**GS# 104-215 Jones Hall Interior Renovations  
Mississippi University for Women**

Addendum No. 2

SHEET **MP106**

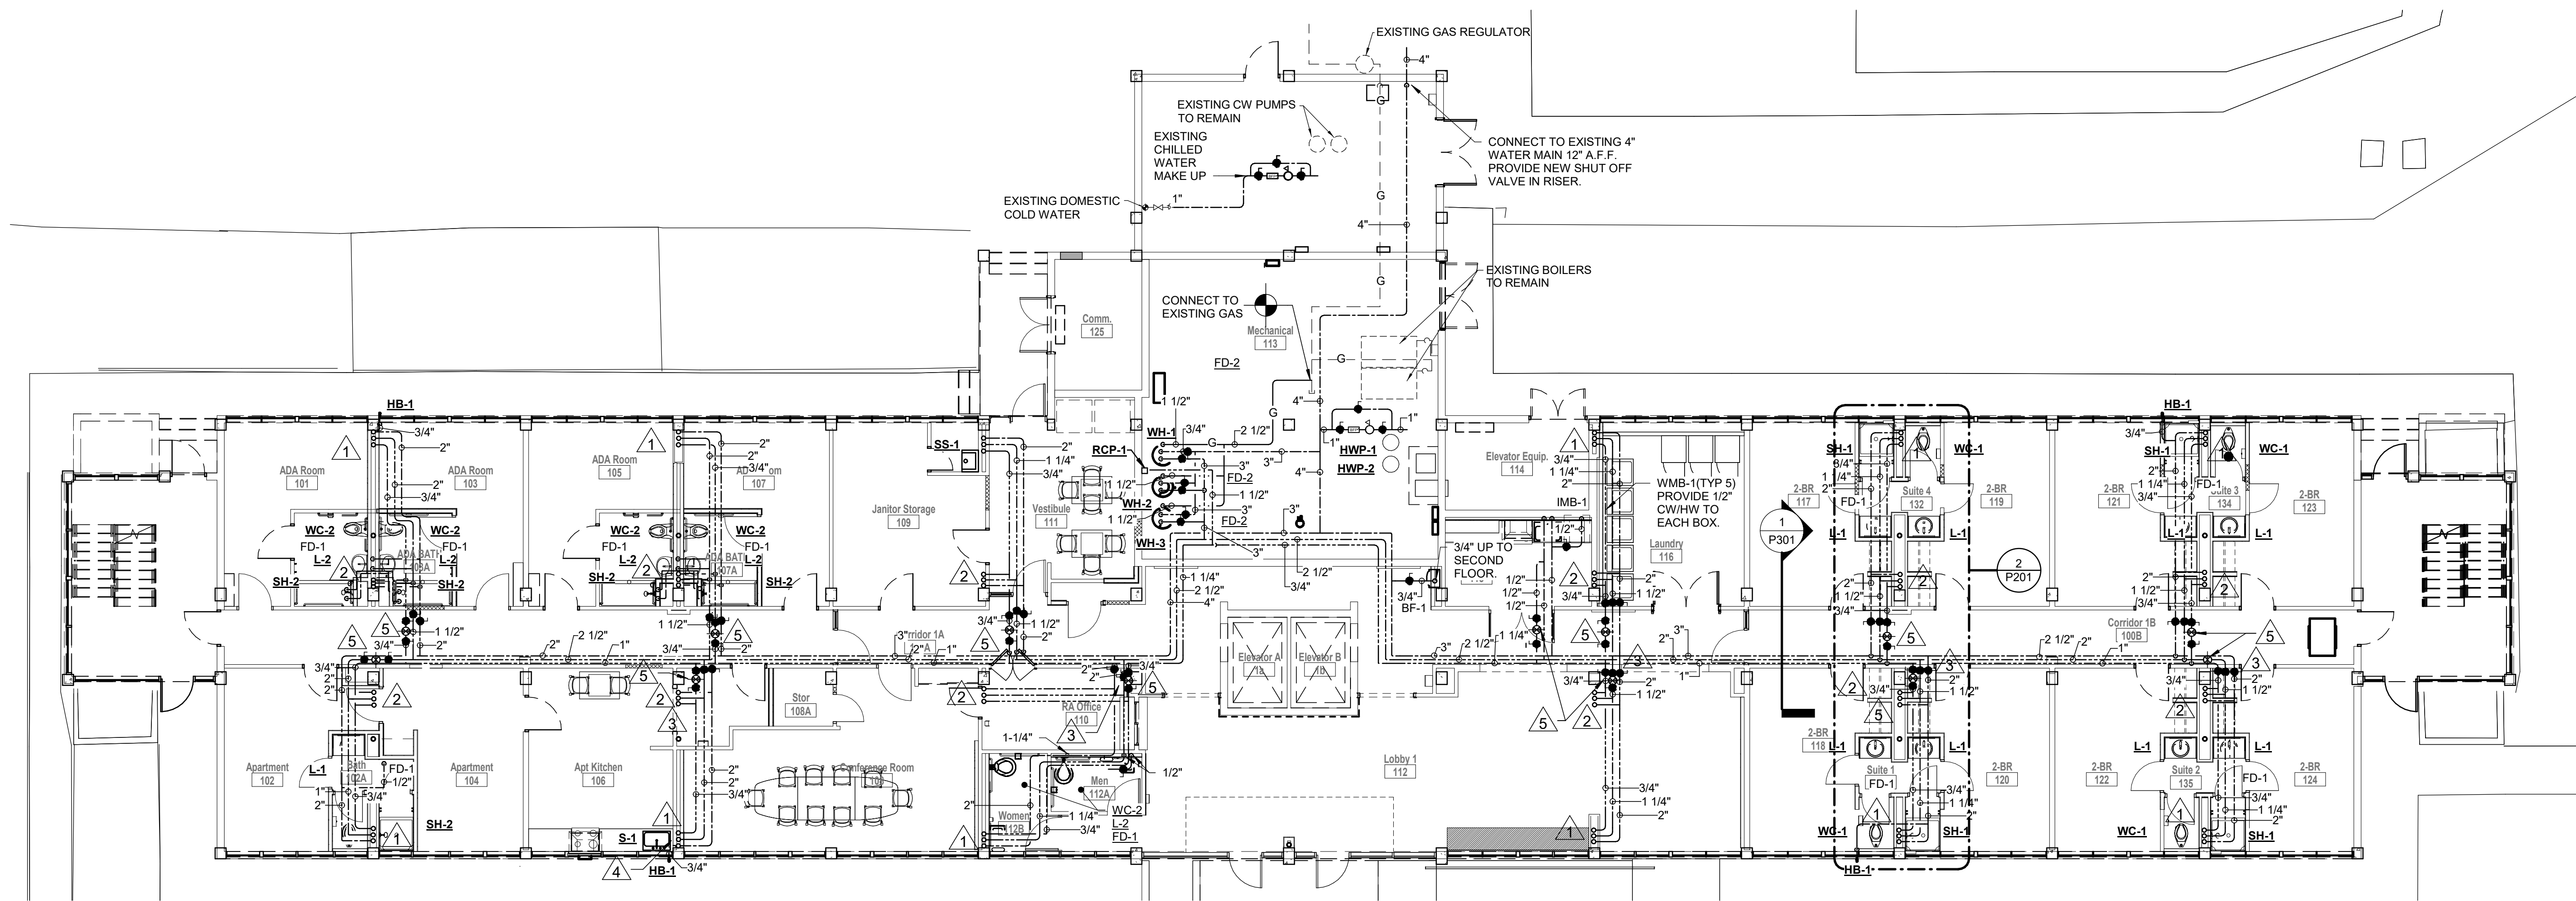
- n. Revise Sheet MP106 and replace with attached Sheet MP106. Revisions included relocating the thermostat for the unit heater and relocating the energy management panel for penthouse.

SHEET **P201**

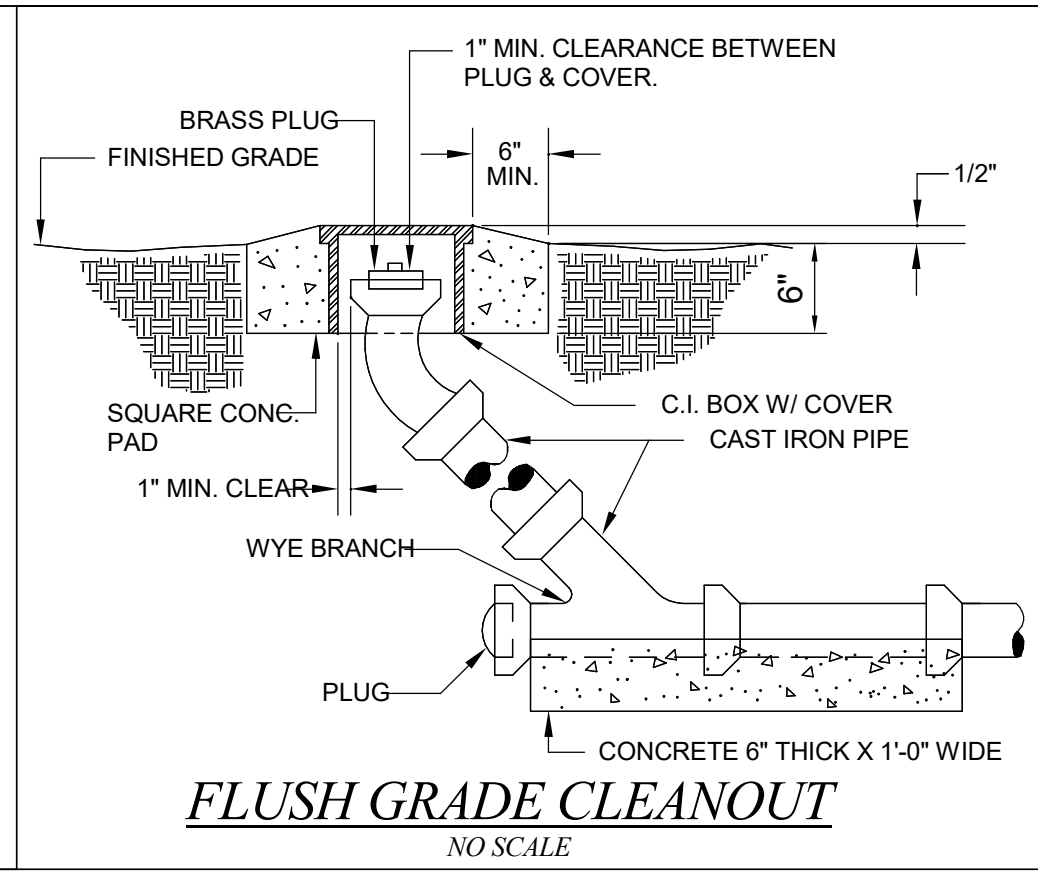
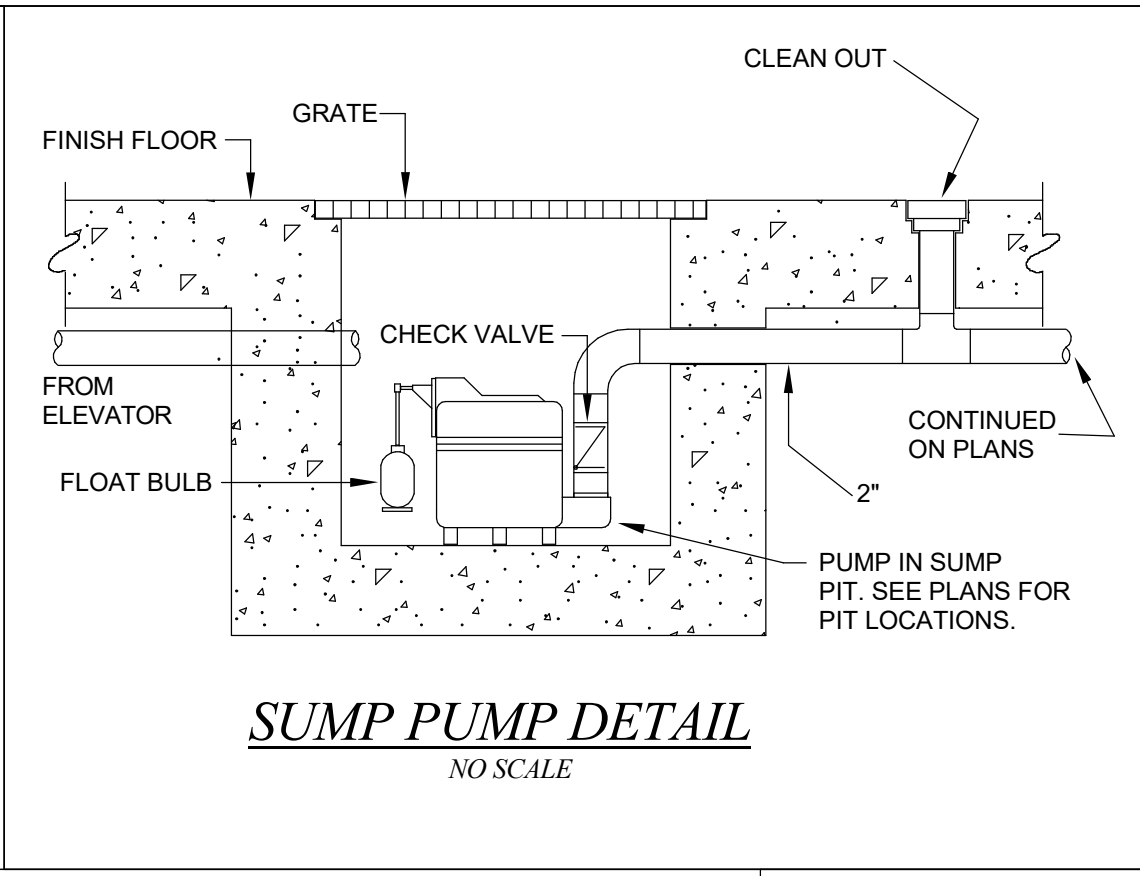
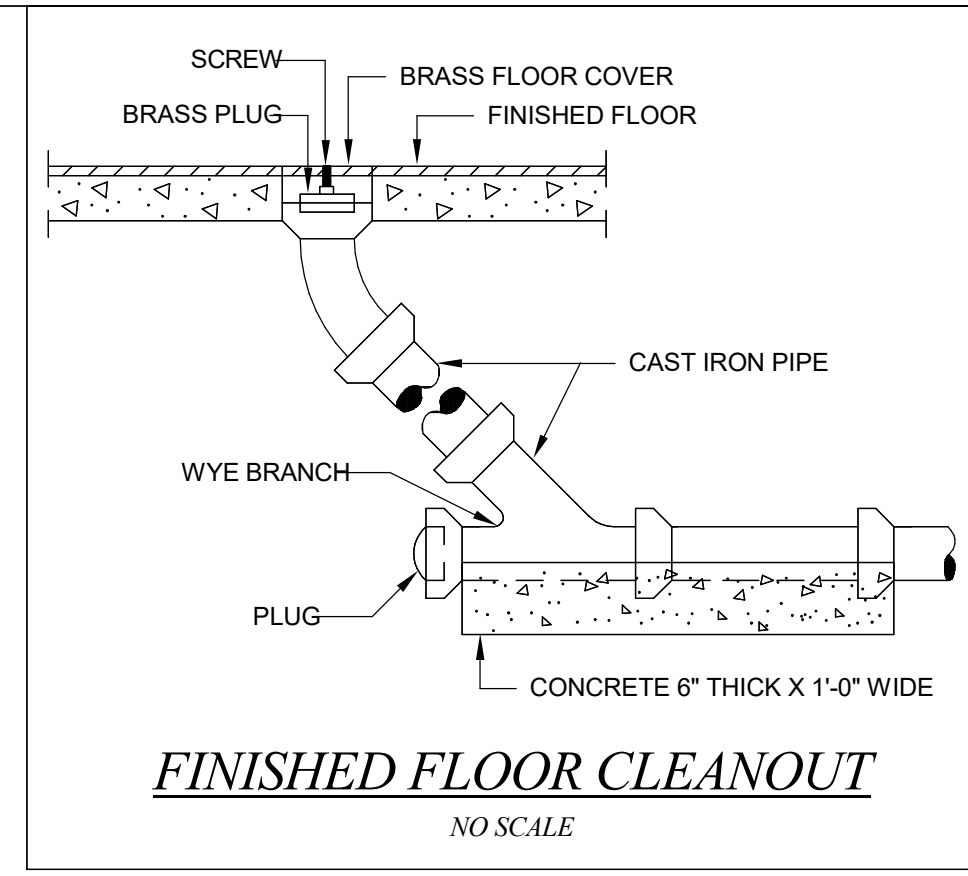
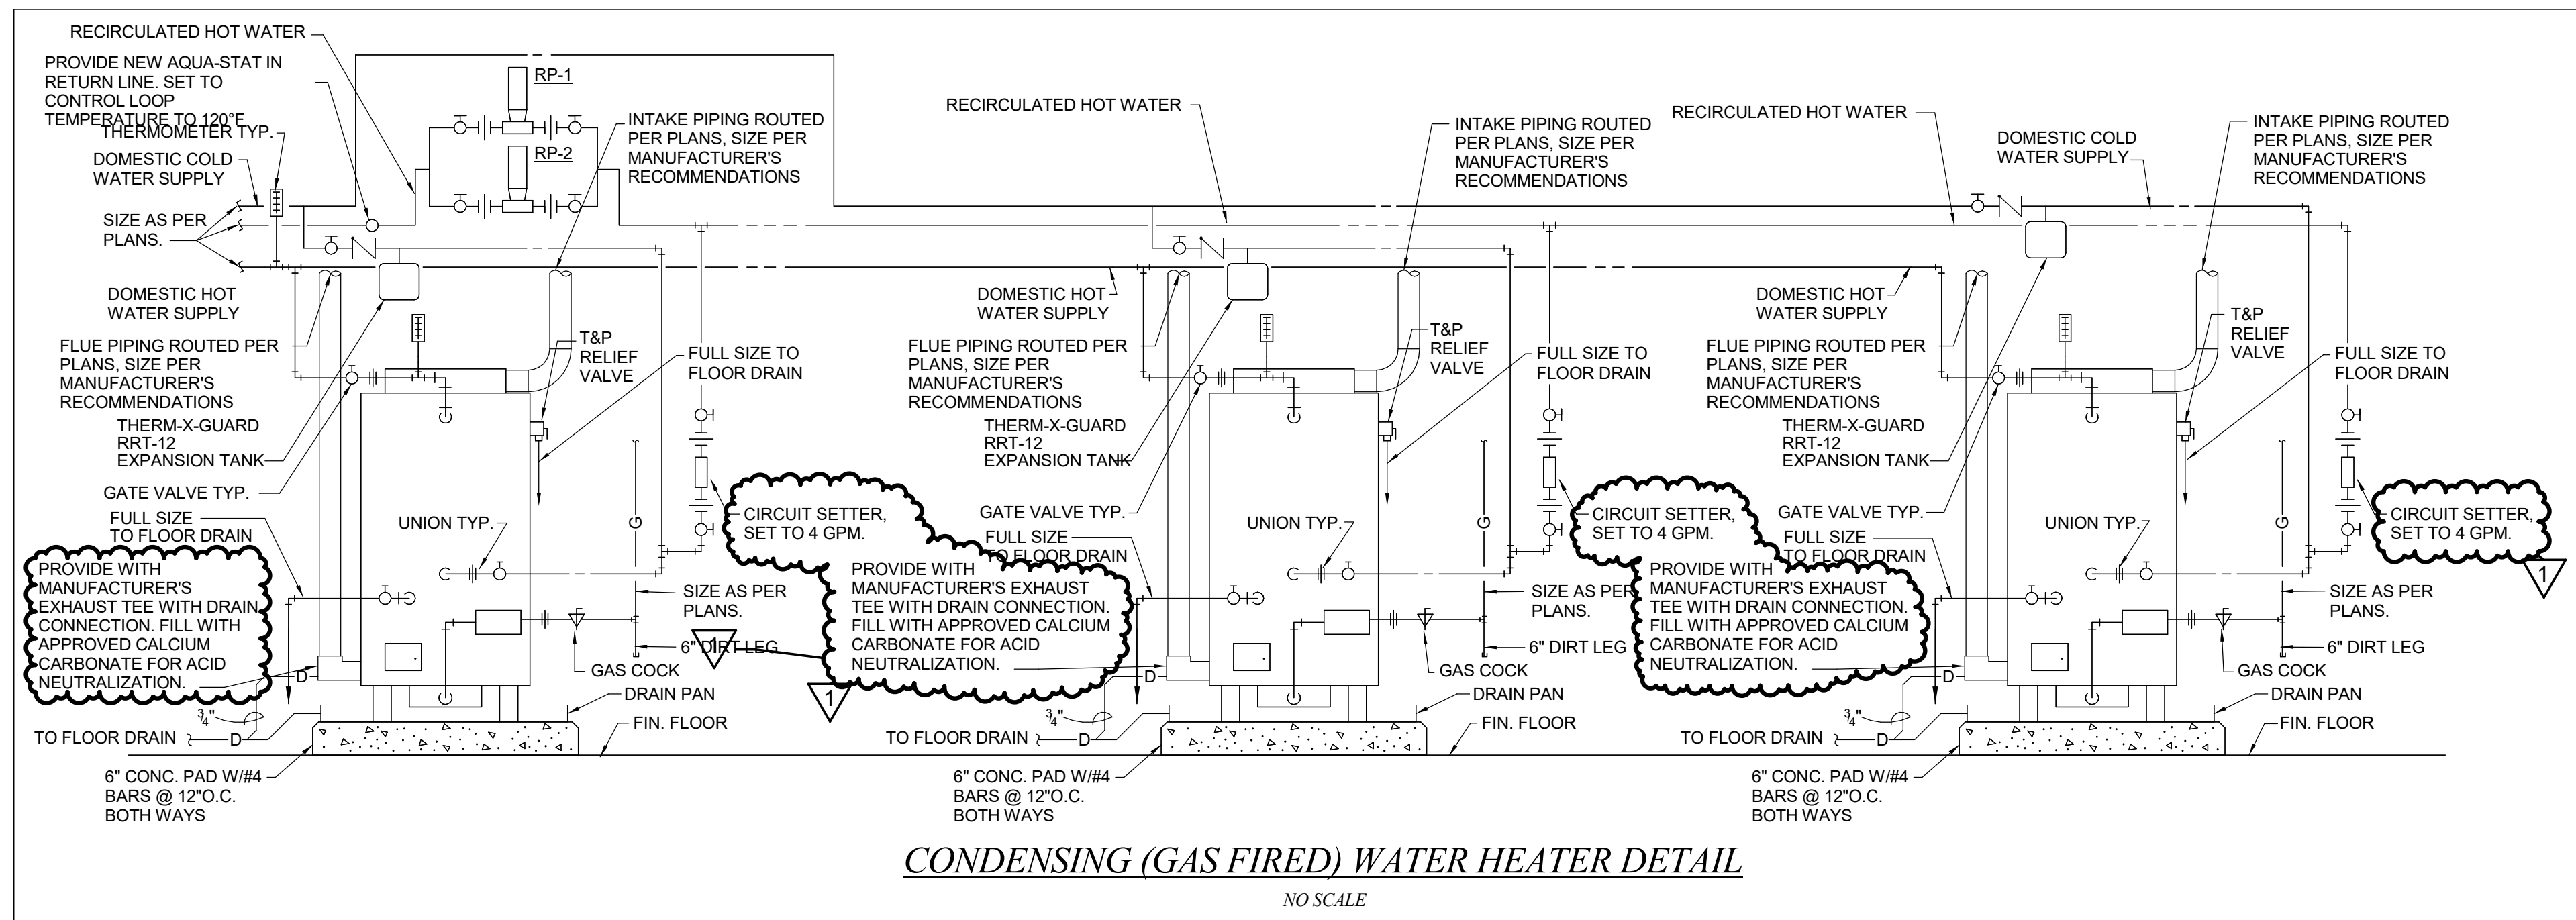
- e. Revise Sheet P201 and replace with attached Sheet P201. Revisions included updating flowrates for hot water balancing valves.
- f. Revise Sheet P301 and replace with attached Sheet P301. Revisions included clarification for water heater acid neutralization devices, updating the plumbing fixture schedule to reflect the correct fixture type, and updating section detail.

SHEET **E002**

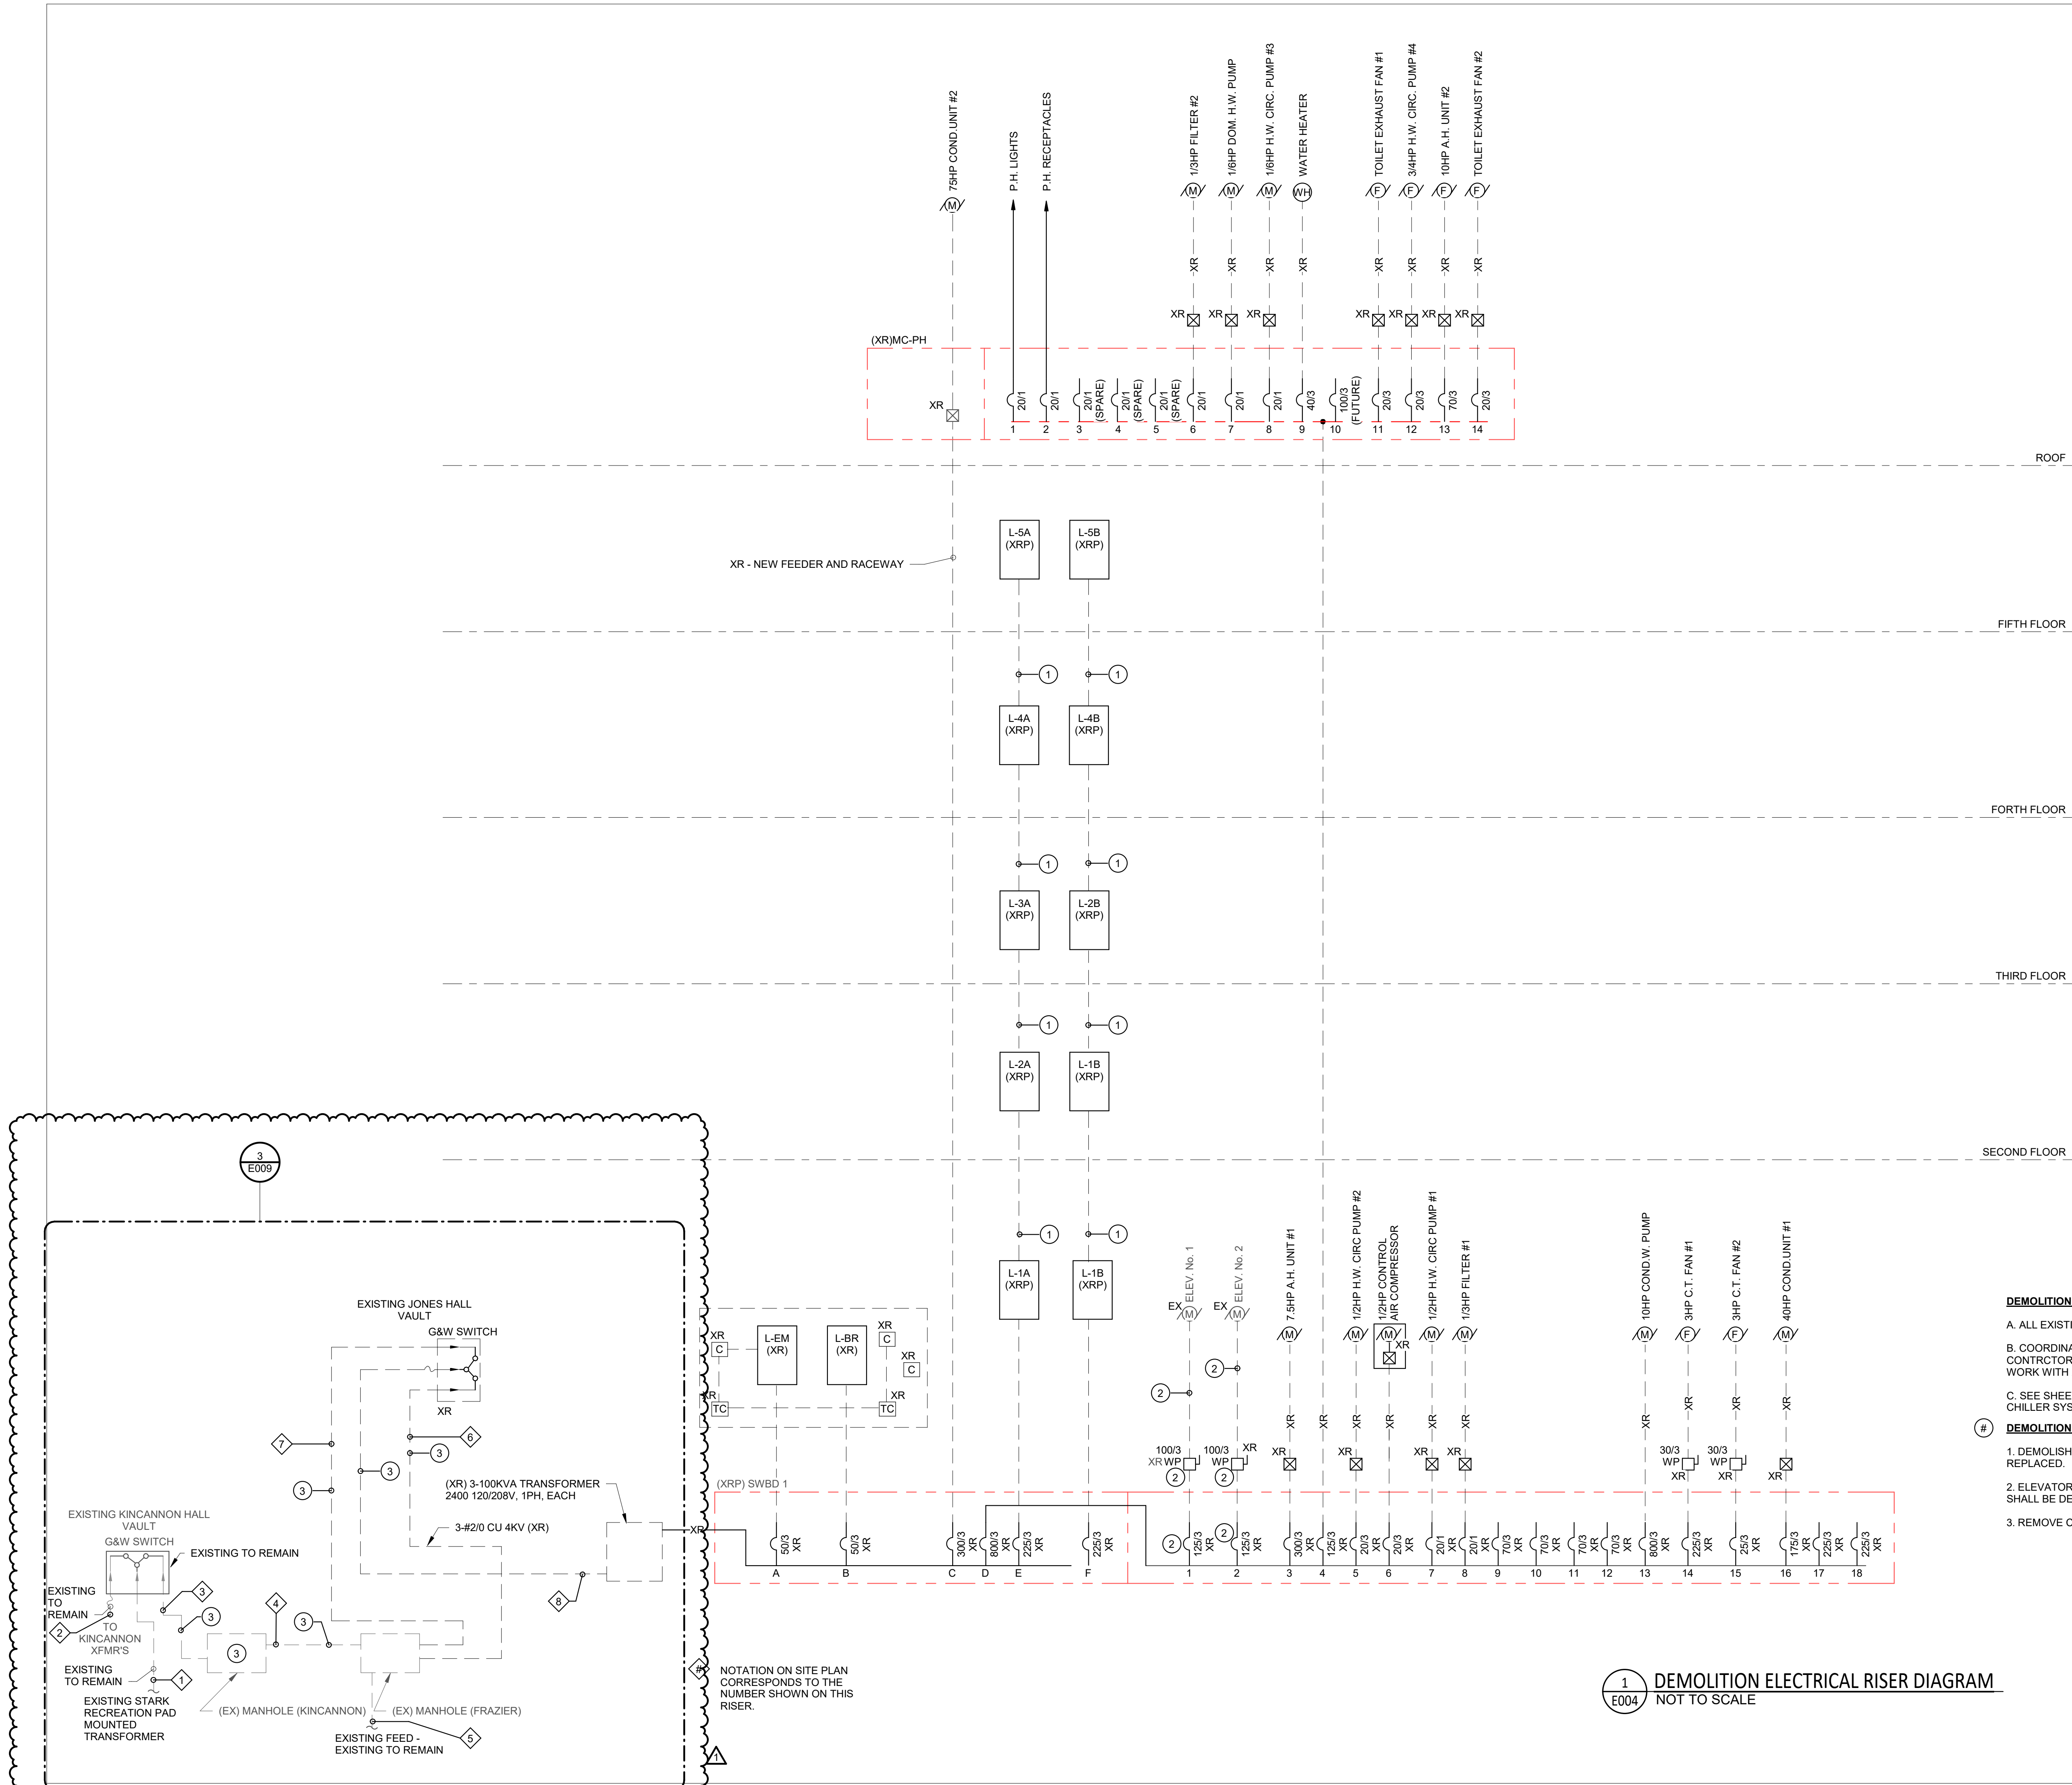
- o. Revise Sheet E001 and replace with attached Sheet E001. Revisions include adding floor box specifications and notes.
- p. Revise Sheet E002 and replace with attached Sheet E002. Revisions include fixing the background for the enlarged bedroom and bathroom view.
